Service Bulletin B2180004A-15

SB, Loose Oil Drain Adapter, RedMax Zero Turn Mowers Equipped with Kawasaki Twin Cylinder Engines, RZT42, RZT48, 2018-04

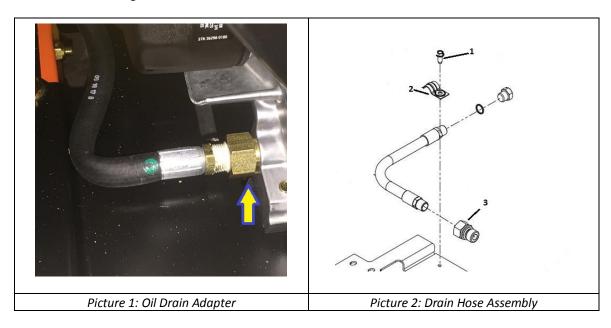
The oil drain adapter may not have been sufficiently tightened. Loose adapters may leak oil resulting in spillage on engine plate and/or loss of oil. Insufficient oil may cause engine failure.

- 1. 1" Open end wrench
- 2. 3/8" wrench
- **Step 1**. Check tightness of oil drain adapter (picture 1) using a 1" open ended wrench.
 - If loose proceed to step 2.
 - If tight, no further action is needed.

Step 2. If adapter is loose refer to picture 2.

- Remove self-tapping screw (item 1) and clamp (item 2) to allow hose to rotate with adapter.
- Tighten adapter (item 3) until secure.
- Position hose in original position and secure with screw and clamp.
